AGENDA

PLANNING & ZONING COMMISSION REGULAR MEETING TUESDAY, FEBRUARY 21, 2023 - 3:30 PM MCALLEN CITY HALL, 1300 HOUSTON AVENUE CITY COMMISSION CHAMBERS, 3RD FLOOR

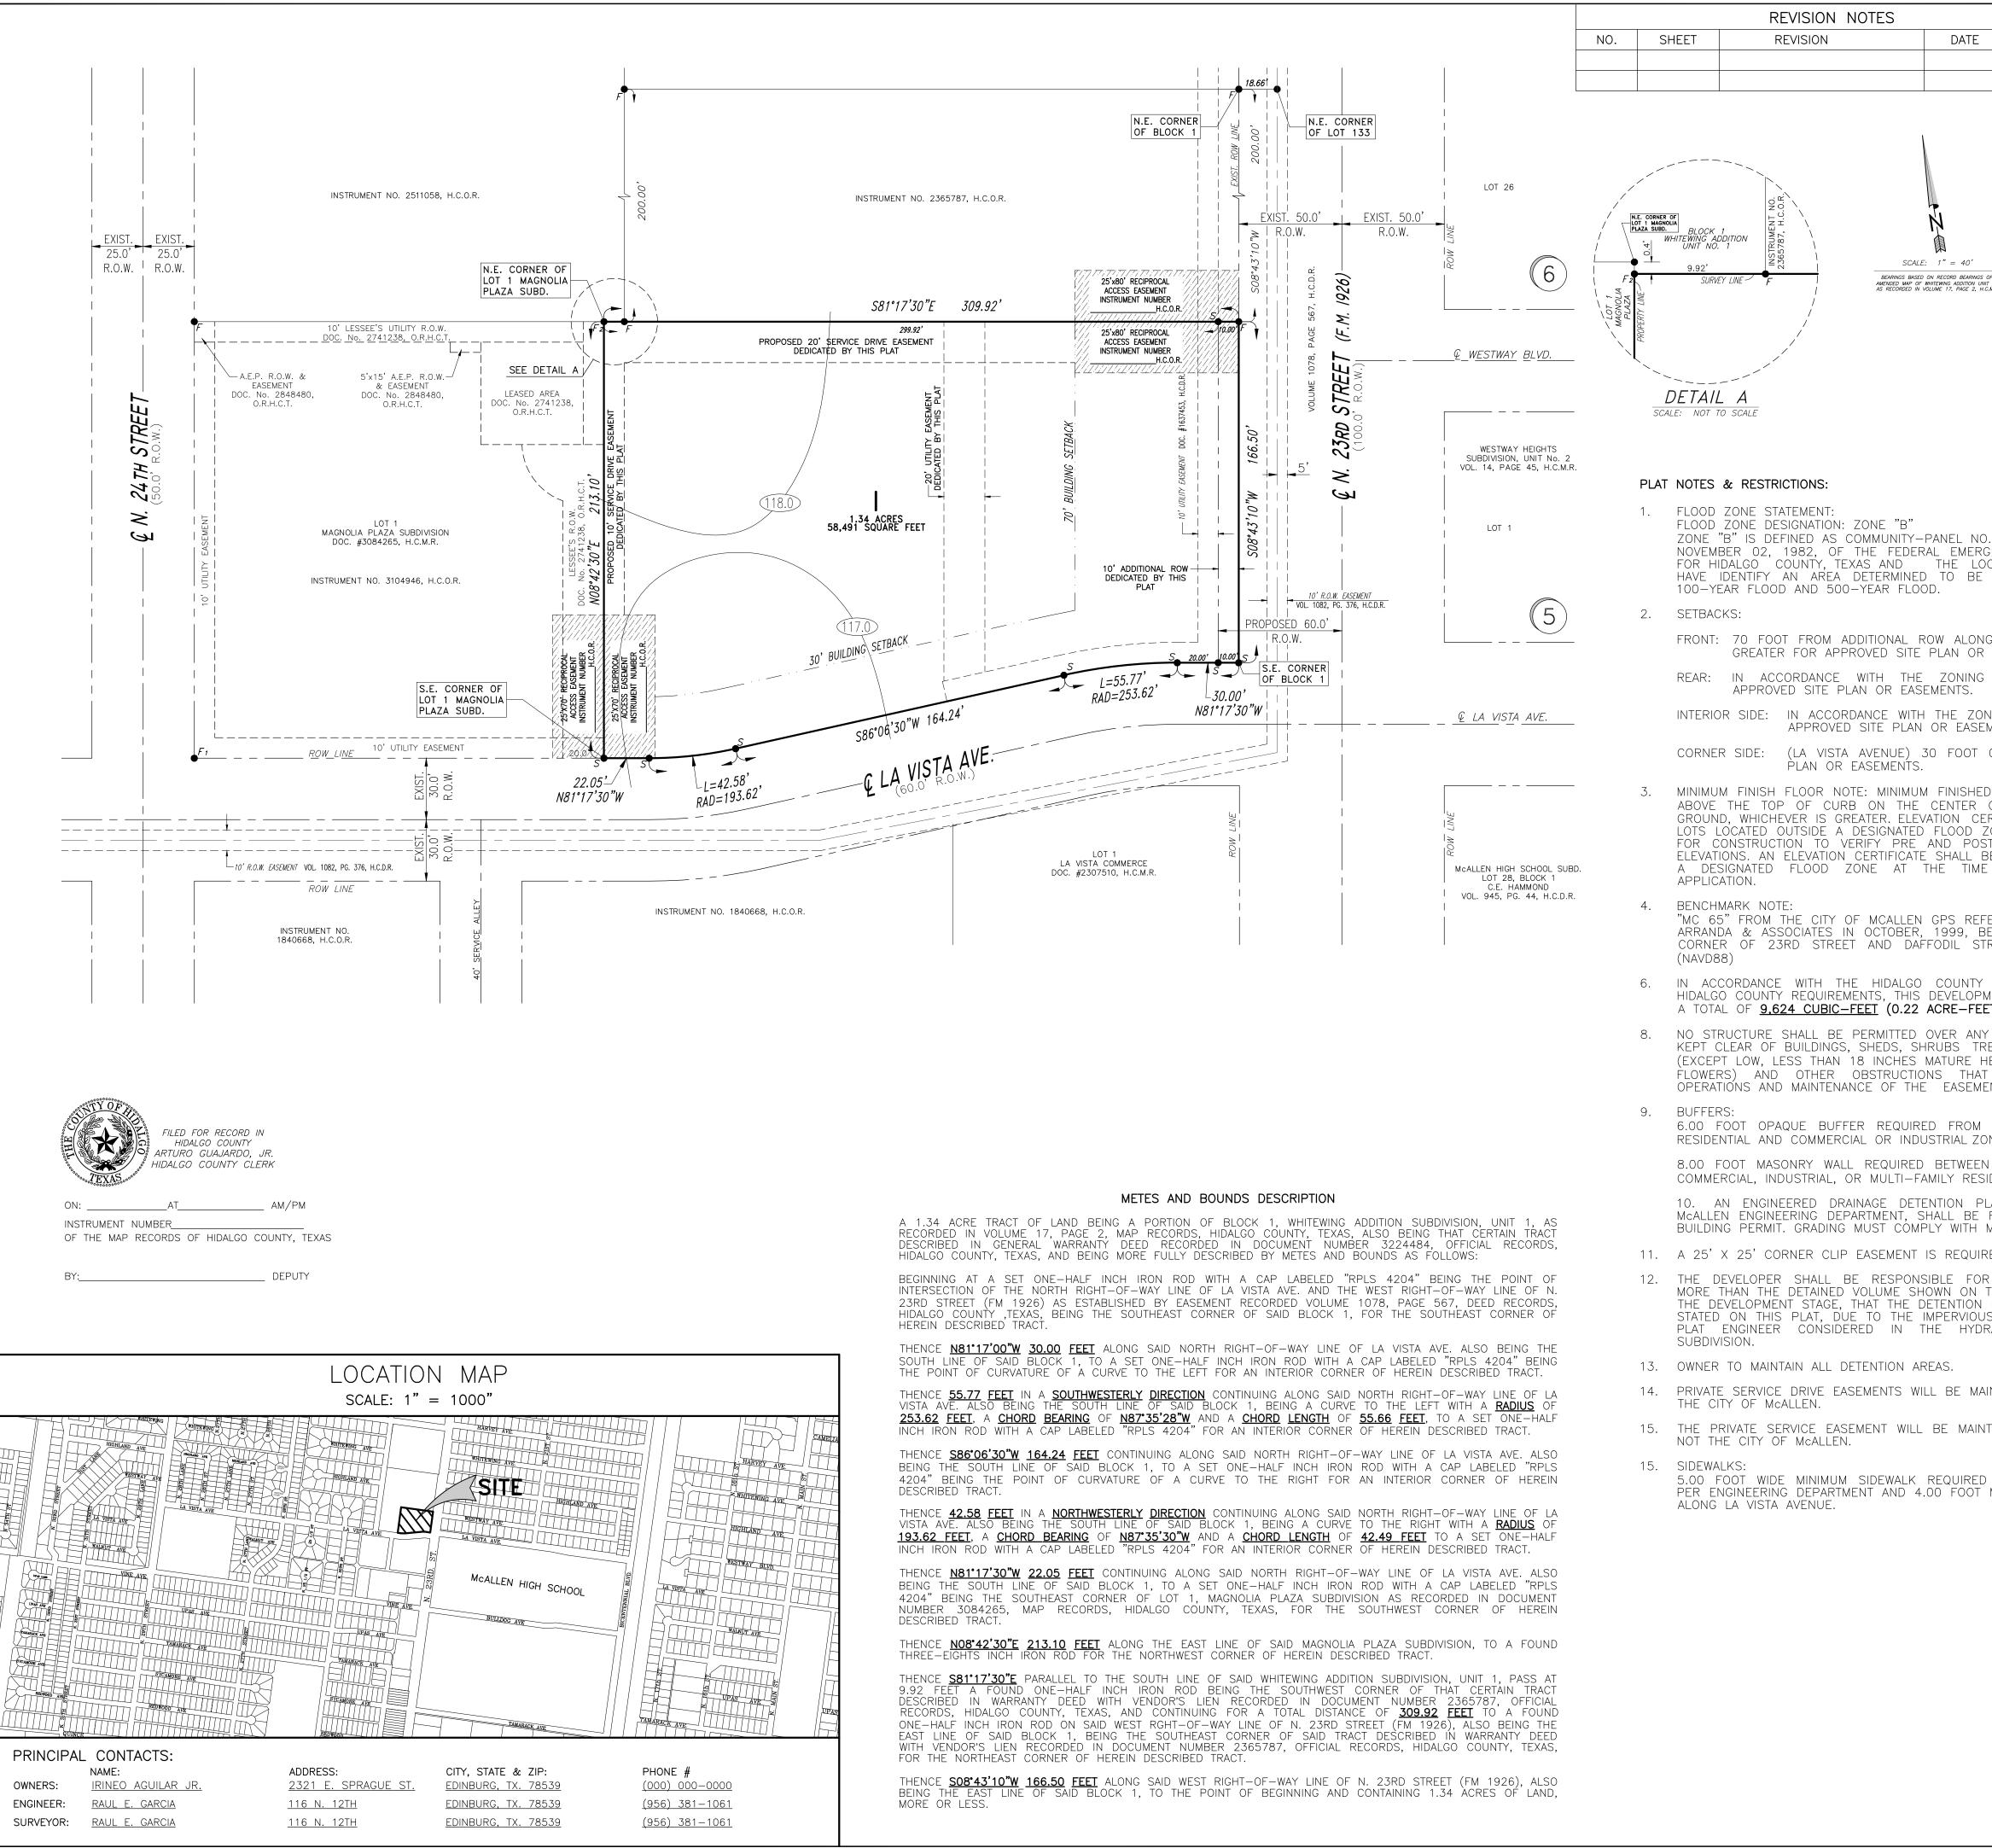
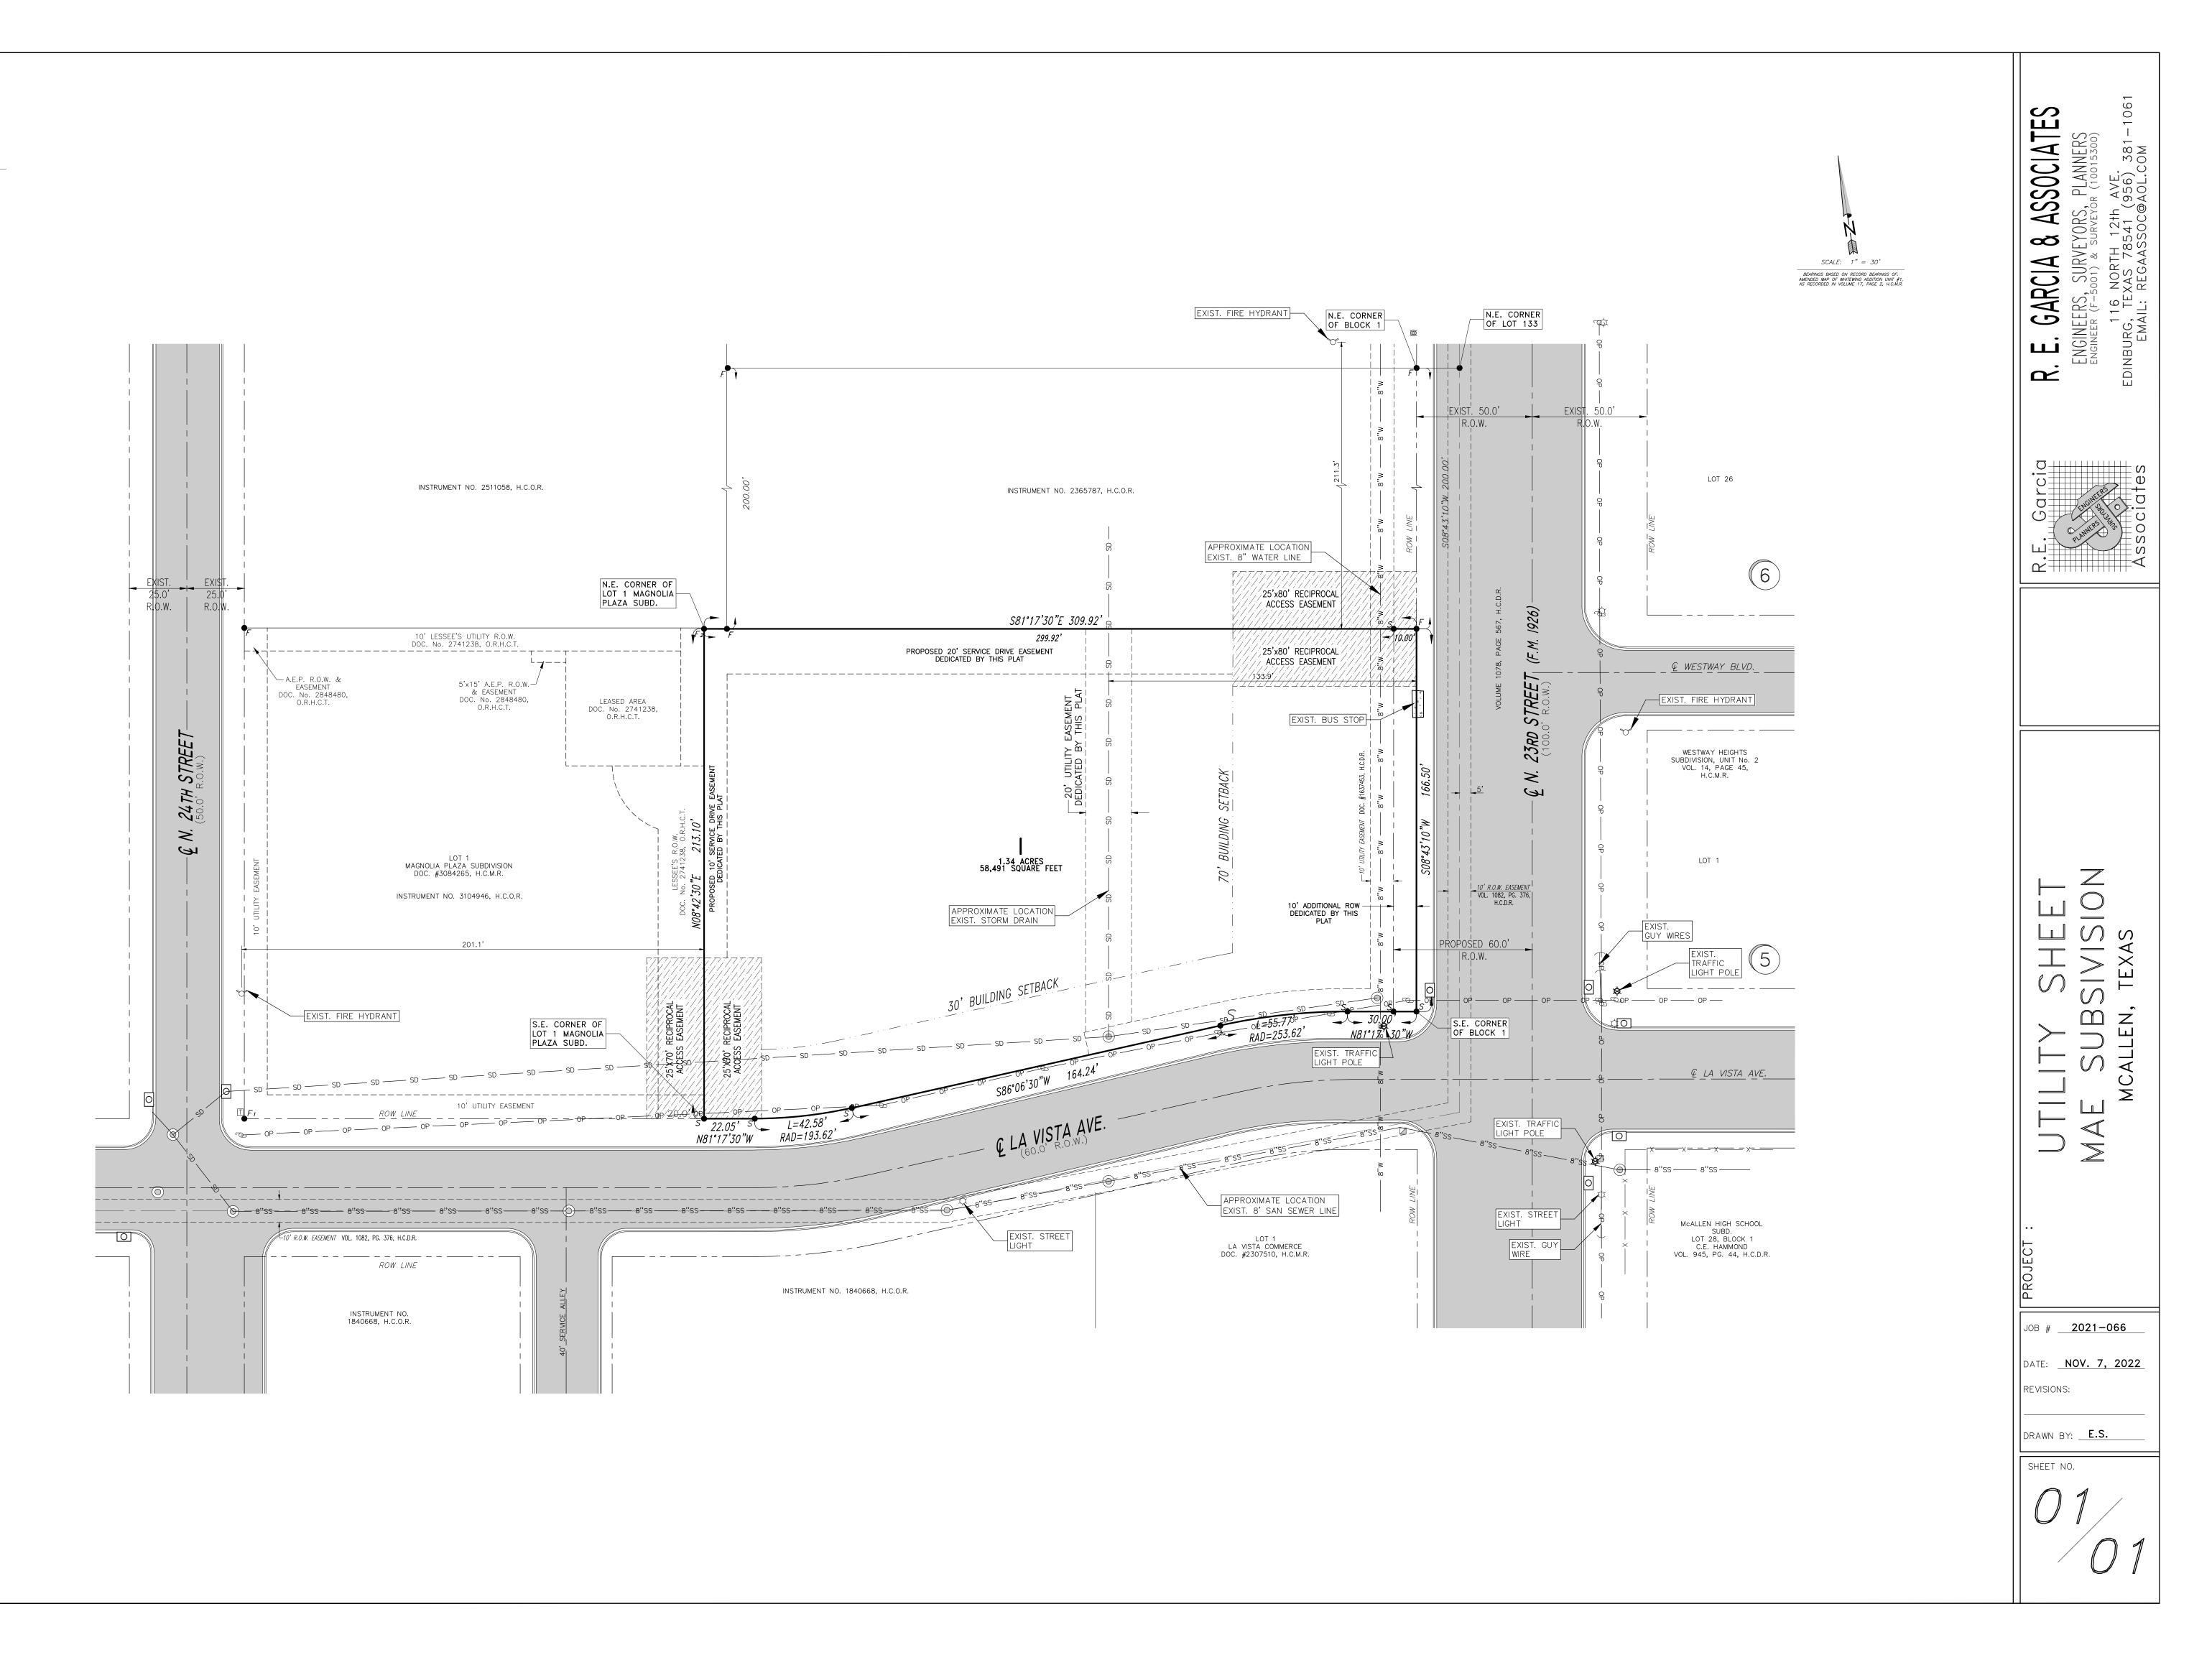
SUBDIVISION NAME: MAE SUBDIVISION	
REQUIREMENTS	
TREETS AND RIGHT-OF-WAYS	
 N. 23rd Street (FM 1926): 50 ft. ROW required from centerline for 100 ft. total ROW Paving: by the state Curb & gutter: by the state Revisions needed: -Dedication as needed for 100ft. Total ROW, existing dedication must be finalized, prior to recording. - Label how existing ROW was dedicated to determine if any additional dedication is required prior to recording. - Plat proposing 10 ft. dedication, finalize prior to recording. **Subdivision Ordinance: Section 134-105 and/or COM Thoroughfare Plan **Monies must be escrowed if improvements are required prior to recording. 	Required
La Vista Avenue: 60 ft. ROW Paving: 40 ft. Curb & gutter: both sides **Subdivision Ordinance: Section 134-105 and/or COM Thoroughfare Plan **Monies must be escrowed if improvements are required prior to recording.	Applied

ALLEYS		
 ROW: 20 ft. Paving: 16 ft. Revisions needed: -Private Service Drive Easements must be minimum 24 ft., finalize requirements prior to recording. Dedication as needed for minimum 24 ft. Private Service Drive, ensure that alignment and dedications from adjoining properties are finalized prior to recording. If dedication by adjoining properties is being utilized dedication by separate instrument may be required. Finalize Private Service Drive Easement requirements prior to final. -Remove proposed from service drive labeling and should be revised to "Private service drive easement", revise were applicable prior to recording. Remove notes #15 as requirement is addressed by plat note #14, prior to recording. *Alley/service drive easement required for commercial properties 	Required	
SETBACKS

* N.23rd Street/ La Vista Avenue: As shown on plat or greater for easements or approved site plan, whichever is greater applies. Revisions Needed: -Revise note as shown above prior to recording. -On plat show dimension from new property line to 70.0 Front Building Setback line, prior to recording. **Proposing:70 Foot from additional ROW along N. 23rd Street (FM 1926) or greater for approved site plan or easements, finalize prior to recording if from original lot line. ***Zoning Ordinance: Section 138-356 	Required

* Rear: In accordance with the Zoning Ordinance or greater for easements or approved site plan, whichever is greater applies. Revisions Needed: Revise note as shown above prior to recording. **Proposing: In accordance with the zoning ordinance or greater for approved site plan or easements. ***Zoning Ordinance: Section 138-356 	Applied

* Interior Sides: In accordance with the Zoning Ordinance or greater for easements or approved site plan, whichever is greater applies. Revisions Needed: Revise note as shown above prior to recording. **Proposing: In accordance with the zoning ordinance or greater for approved site plan or easements. ***Zoning Ordinance: Section 138-356 	Required

* Corner side (La Vista Avenue): See front setback note above. Revisions: -Refer to front setback note for required revision, finalize prior to recording. *Proposing:30 ft. or greater for approved site plan or easements **Zoning Ordinance: Section 138-356 	Required

SIDEWALKS	
 * 5 ft. wide minimum sidewalk required on N. 23rd Street (FM 1926) and 4 ft. minimum wide sidewalk required along La Vista Avenue. Revisions needed: Revise note as shown above prior to recording. **5 ft. sidewalk required along N. 23rd Street per Engineering Department ***Proposing:5 ft. wide minimum sidewalk required on N. 23rd Street (FM 1926) per engineering department and 4 ft. minimum wide sidewalk required along La Vista Avenue. ****Subdivision Ordinance: Section 134-120 	Required
